# **Air Accident Investigation Central Directorate**

**Final Incident Report**

**Involving Emirates Airlines**

**At Khartoum Airport**

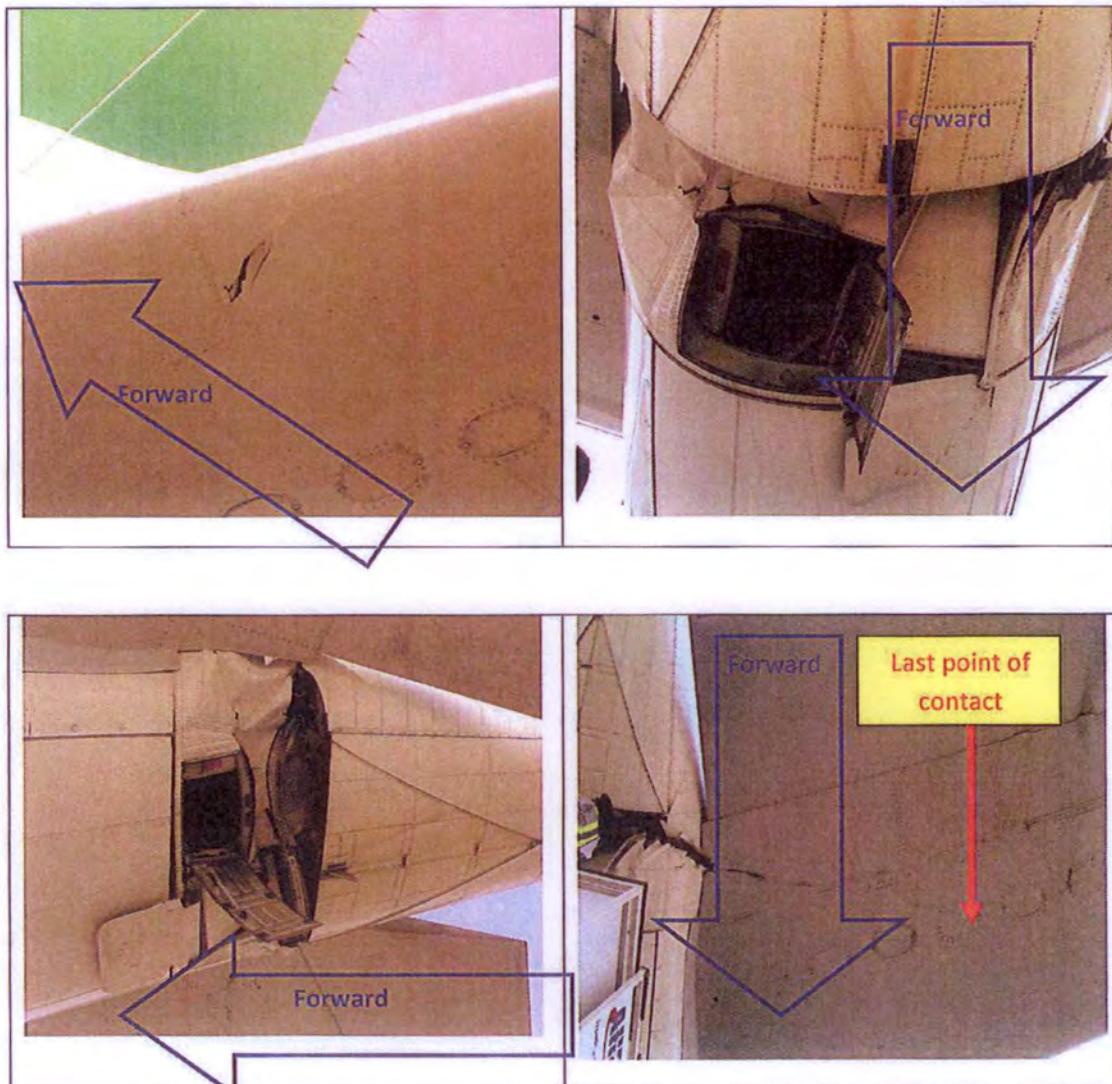
**Remarks:** We suggest to include the text of paragraph 1.17 Organization and Management Information of your report in paragraph 1.1.

**Rationale:** We consider the details of the measurement relating to how the A345 aircraft was parked falls under 1.1 History of the flight as it included flight preparation, or the state the aircraft was prior to ground collision incident.

#### ***Paragraph 1.3 Damage to Aircraft***

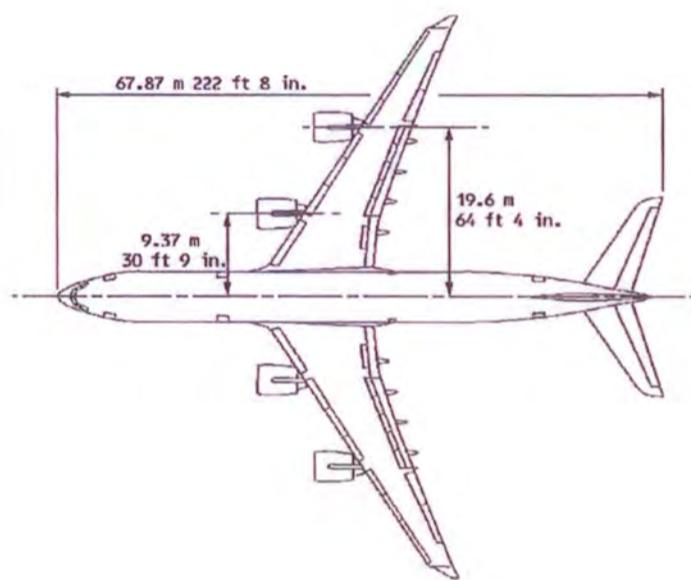
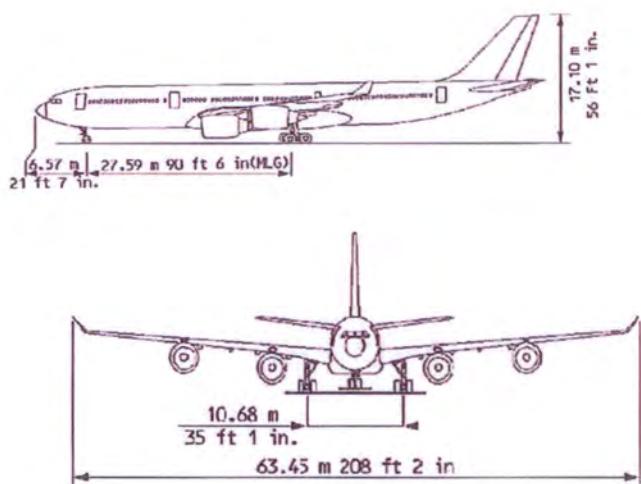
**Remark:** We suggest you consider including the suggested text as well as photographs below.

**Rationale:** The text as well as photographs below will enhance overall understanding of the damage.

The A345 aircraft sustained damage to the tail cone, aft fuselage lower frame 91, the left and right stabilizer, APU inlet splitter and the APU fire bottle compartment access door (see pictures below). The A332 aircraft sustained damage to the left winglet. The 345 flight was cancelled and the aircraft was removed from service for repairs. The A332 aircraft was released for service.

#### Paragraph 1.6 Aircraft Information

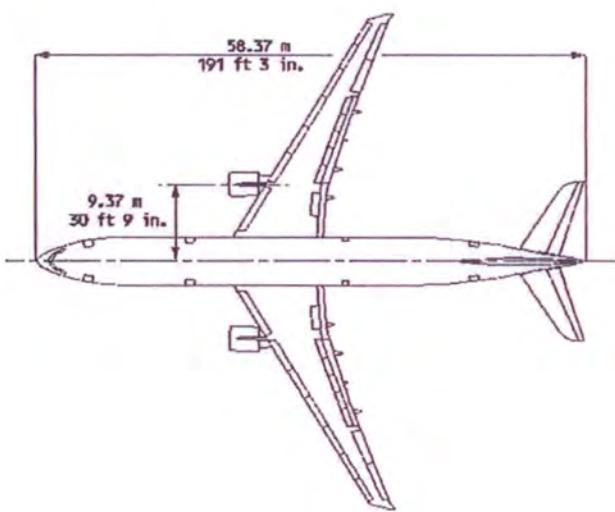
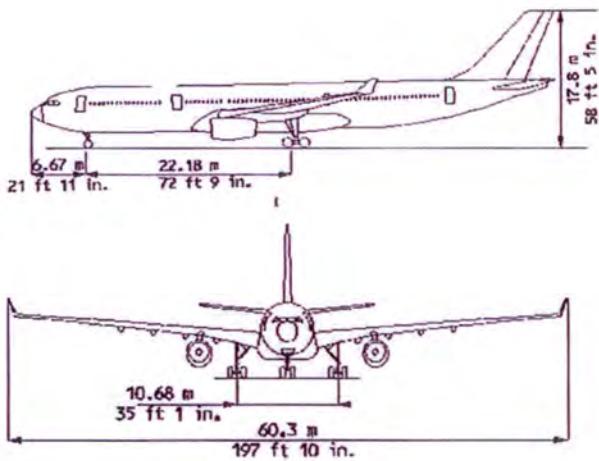
Remark: We suggest you consider include the aircraft dimensions depicted below.

Rationale: The dimensions below will enhance the overall understanding of the aircraft involved in the collision.

#### Apron / Taxilane Geometry and Aircraft Taxi Simulation

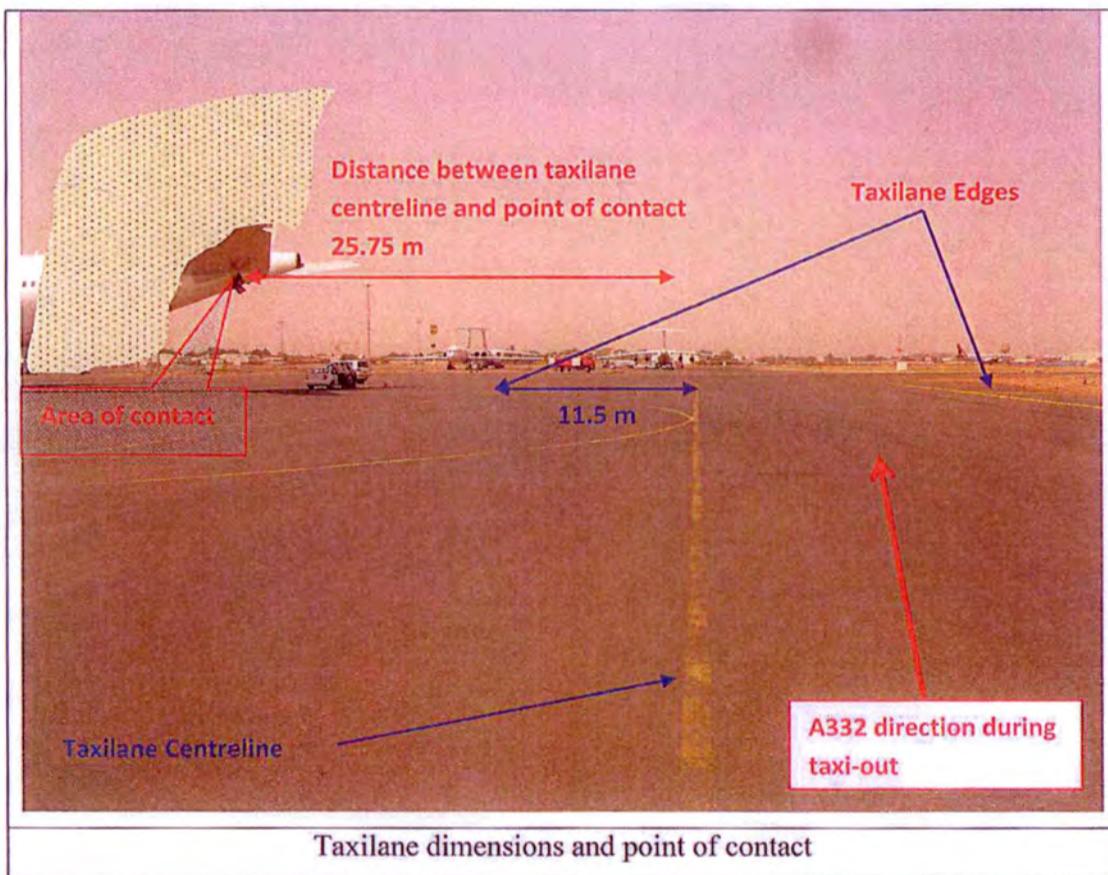
Remarks: We suggest you delete words "No test or research took place" and replace with the suggested text and photo below.

Rationale: We consider the text will enhance the awareness of the reader.

The KRT airport taxilane is 23 metres wide, and meets the ICAO Annex 14 specification for design of taxiways. The ICAO Annex 14 recommends that the design of the taxiway should be in a way that when the cockpit of an aeroplane for which the taxiway was intended remained on the taxiway centreline, the distance between the outer main gear and the edge of the taxiway should not be less than 4.5 metres. The taxilane design at KRT meets the criteria for accommodating aircraft based on the distance between the outer main gear and the edge of the taxiway. No provision was made for ensuring the aircraft on taxi maintaining the centreline were clear of obstacle that were on the apron side of the taxilane.

A scaled aircraft was overlaid on a Google Earth to simulate aircraft taxi and the available clearance. The simulation concluded that it was not possible to ensure safe passage of an A332 aircraft behind a parked A345.

It also concluded that safe passage of an A332 aircraft behind another A332 aircraft was only possible if the aircraft operating on the taxilane had the nosewheel either on the taxiway centreline or slightly to the right of the centreline.
